Evaluation of Freshwater Delivery Alternatives to East Matagorda Bay

August 26, 2015

6 Conclusions and Recommendations 46
 6.1 Areas for future study 47
 7 References 48
 8 Appendix A – TWDB comments 50

Figure 5. Annual Estimates of Freshwater Inflow Balance for East Matagorda Bay from 1977 to 2009 (Shoenbaechler and Guthrie 2011).

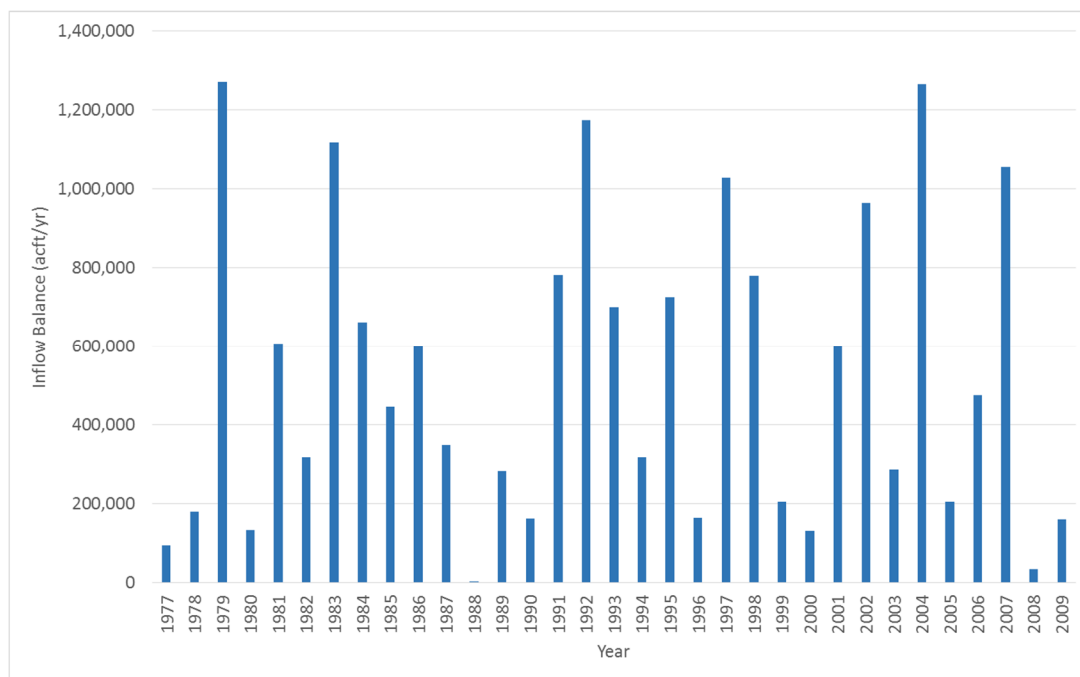
Figure 5. Please add the term “balance” to the figure caption describing “freshwater inflow to East Matagorda Bay” so that it reads, “freshwater inflow balance for East Matagorda Bay”.

Figure 21. Inflow Balance vs. White Shrimp WUA

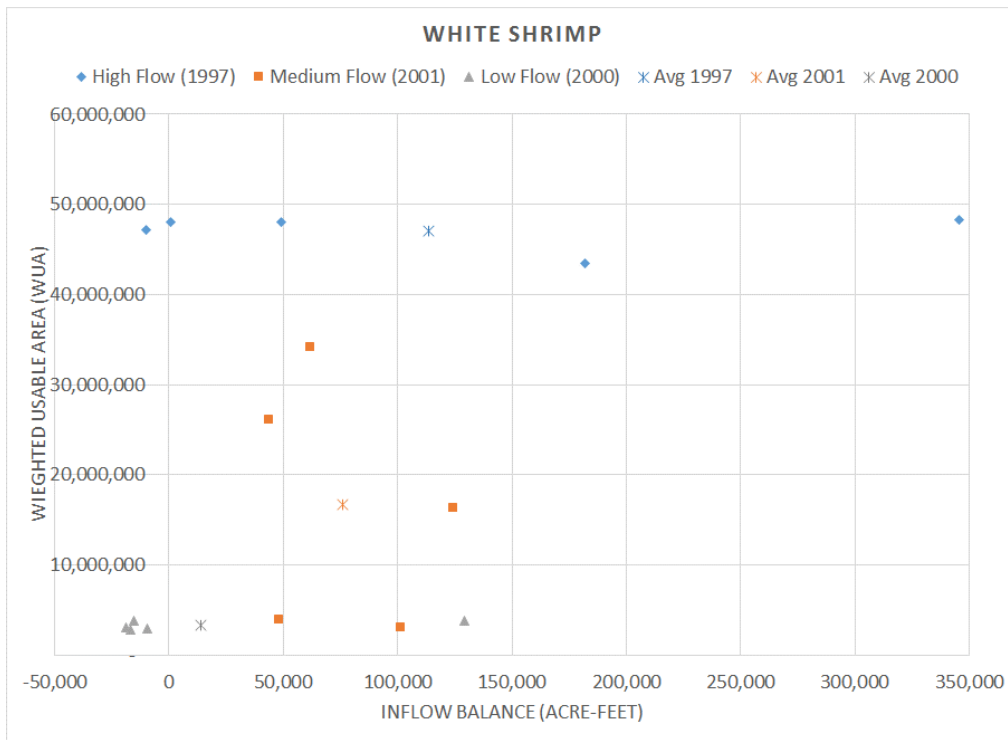
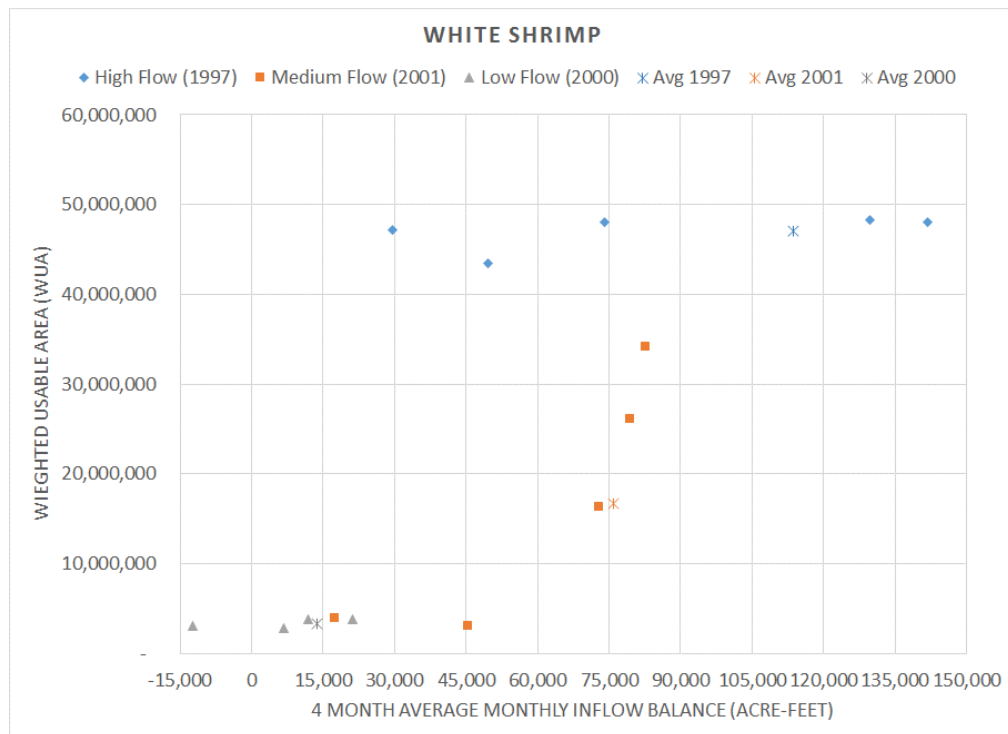
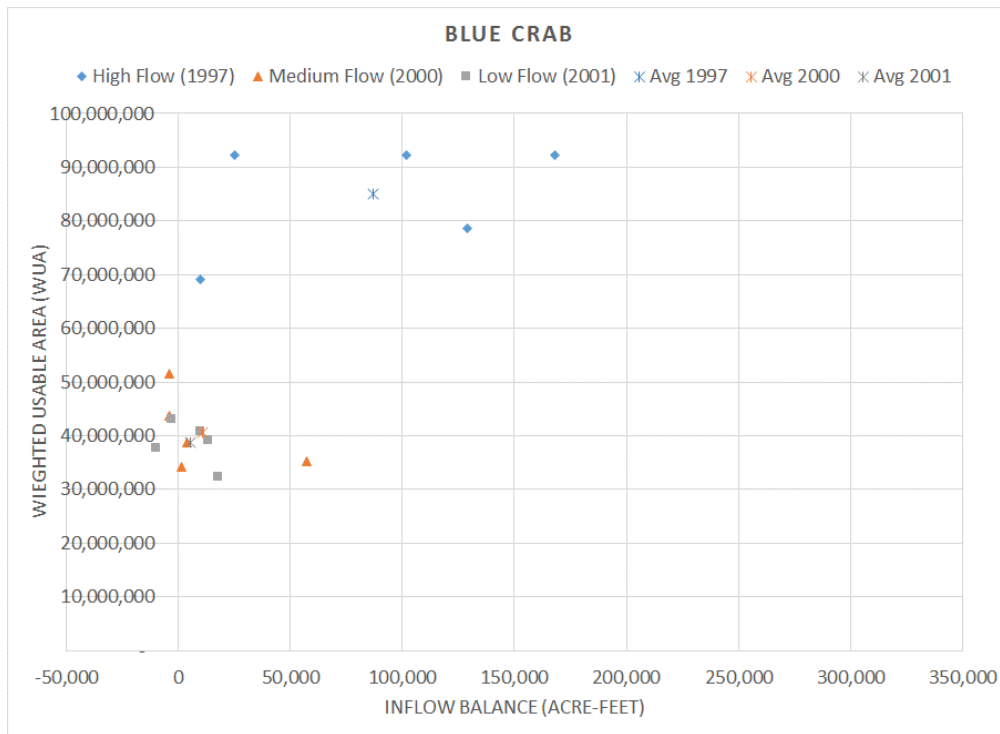
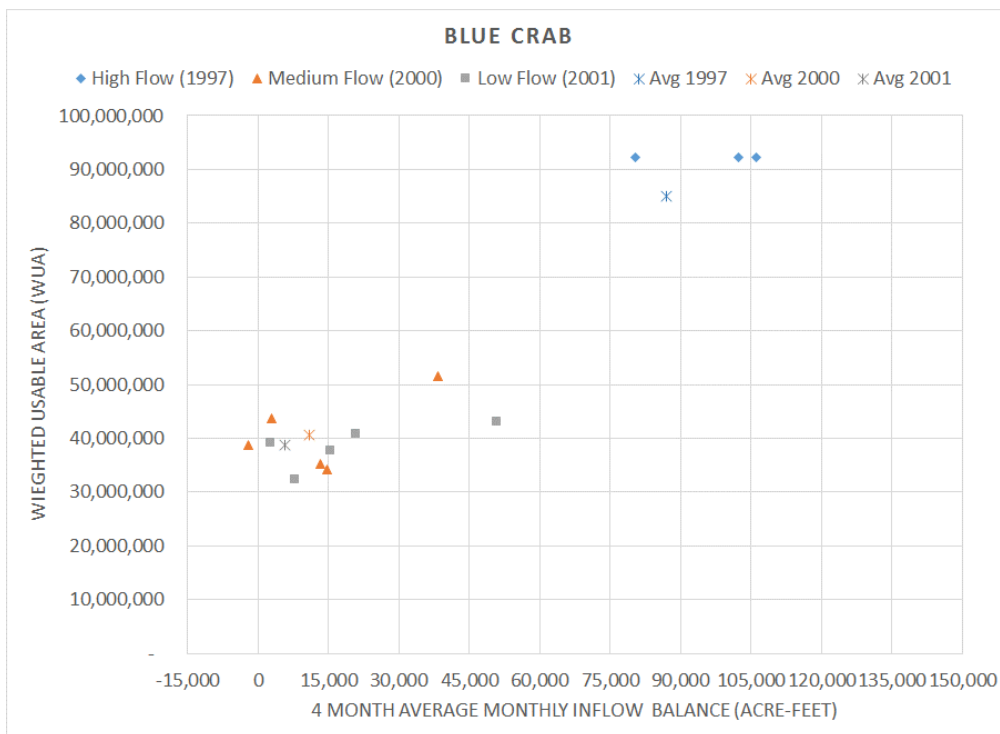
Figures 21 - 24. Please verify the values and provide units for the WUA axis. Note also that the text refers to “blue triangles” for high flow months, but the symbols are better characterized as “blue diamonds”.

Figure 25. White Shrimp Weighted Useable Area (WUA) for selected months during high, medium and low flow years.

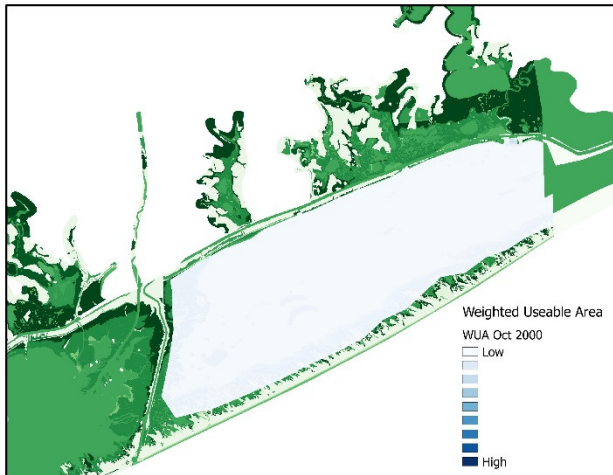
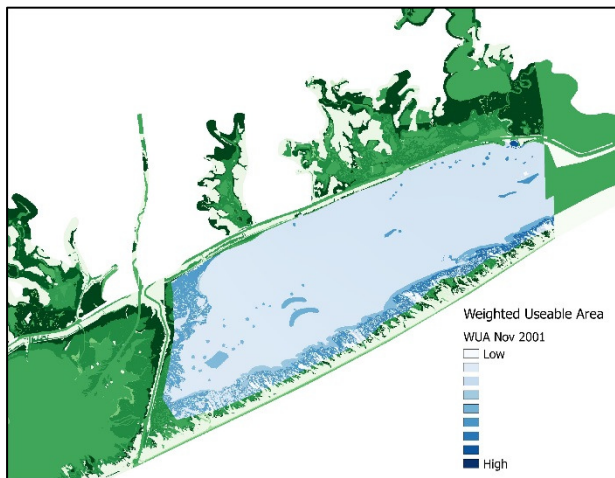
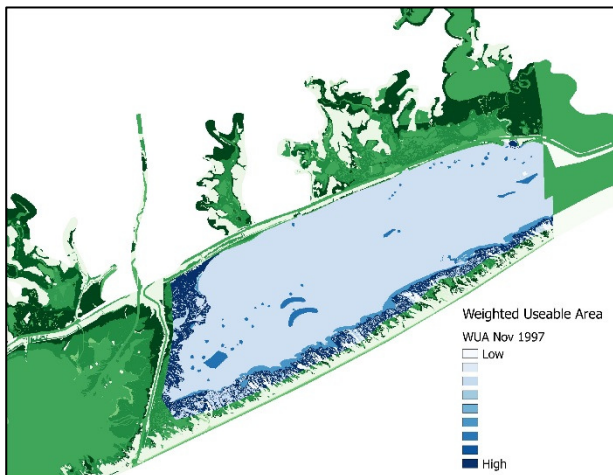
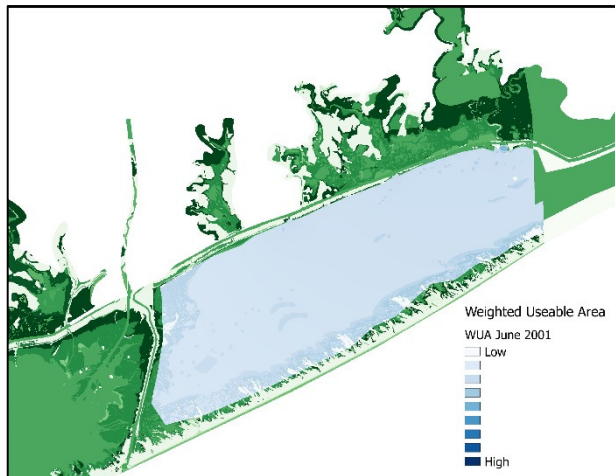
Figure 25. Please verify the values for WUA and provide units.

Figure 32. Freshwater Delivery Pipeline Schematic showing diffuser structure.

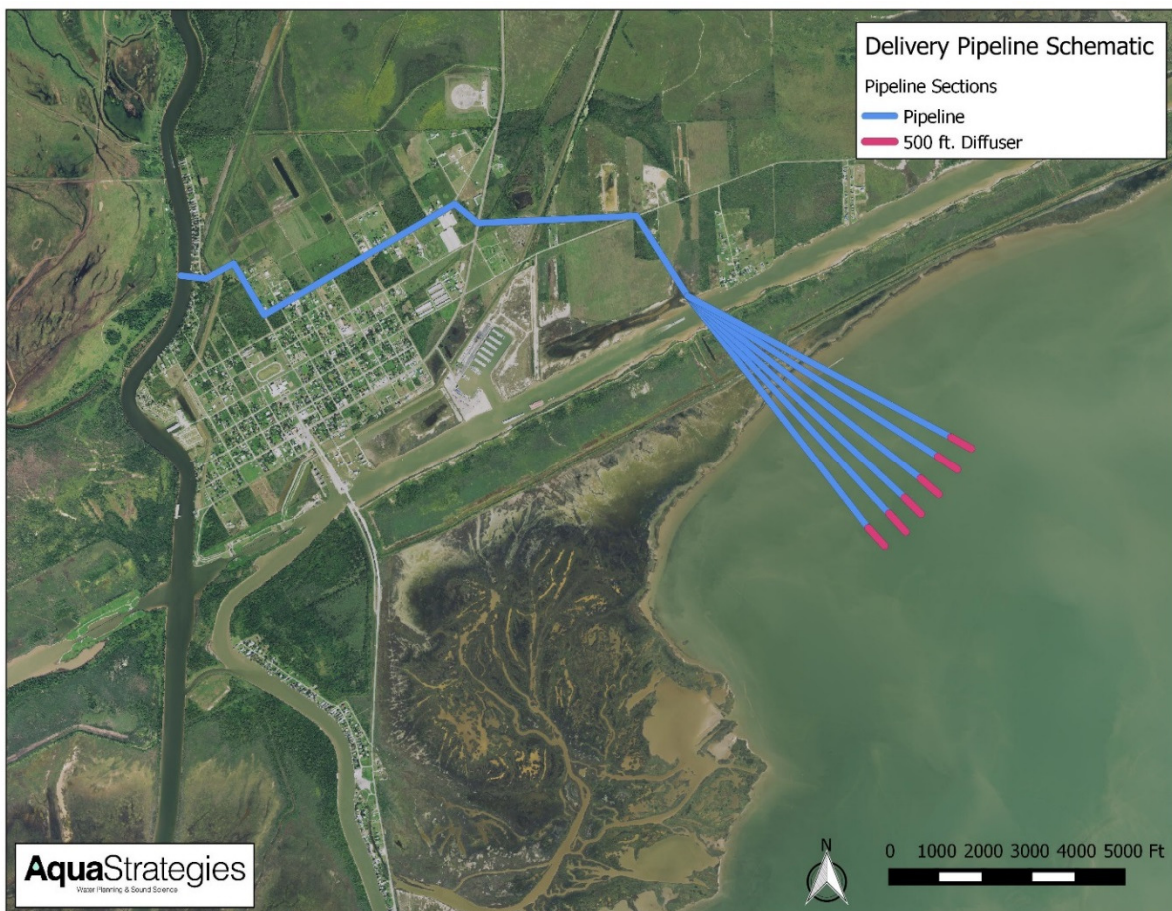
Section 4.1. Estimated Costs for Scenarios, page 40 – A 42-inch pipe is planned for delivering water into East Matagorda Bay, please verify or explain how the pipe dimensions (height in particular) compare to the depth of water in the approximate region it will be placed. Also, please reconcile this description with the depiction in Figure 32.

Figure 32. This figure describes multiple delivery pipes carrying water across the GIWW, but the text on page 40 (*Section 4.1*) describes a single delivery pipe crossing the GIWW.

Figure 33. Illustration of location of proposed Southwest Cut (Kraus and Militello 1996).

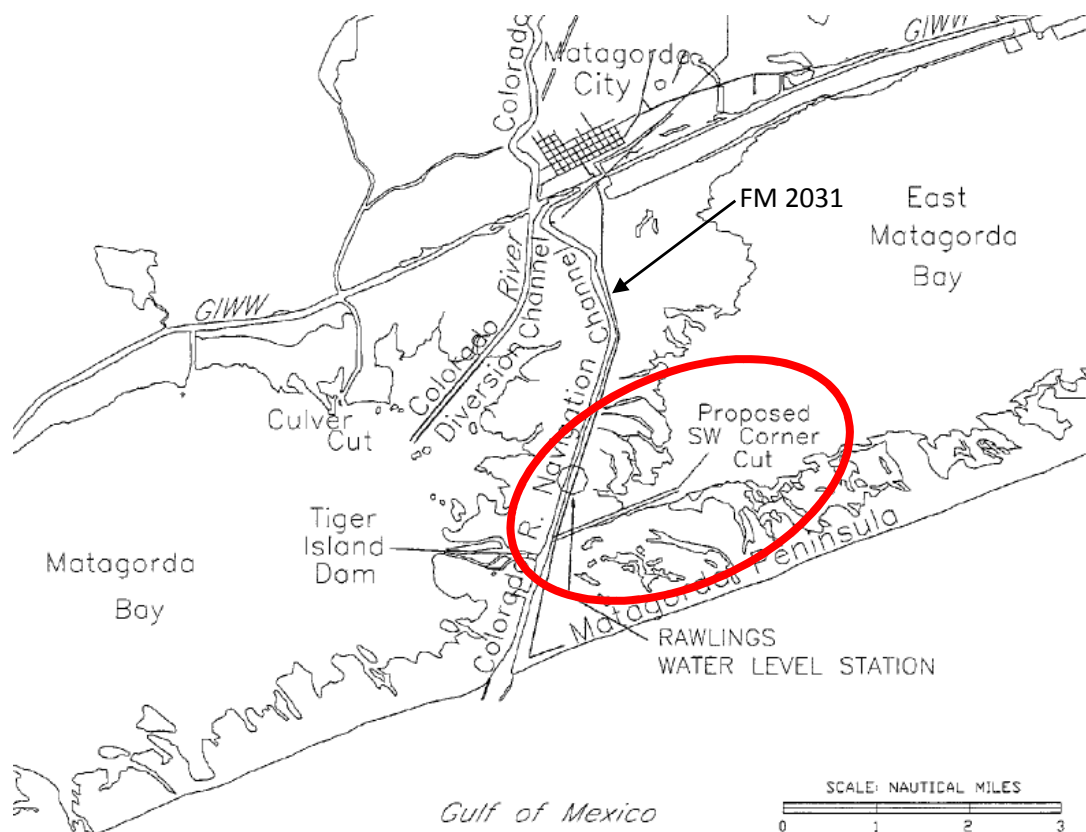
Section 5.2. Southwest Cut, page 45 – The second paragraph discusses FM 2031. Please show this location on Figure 33 or another appropriate figure.
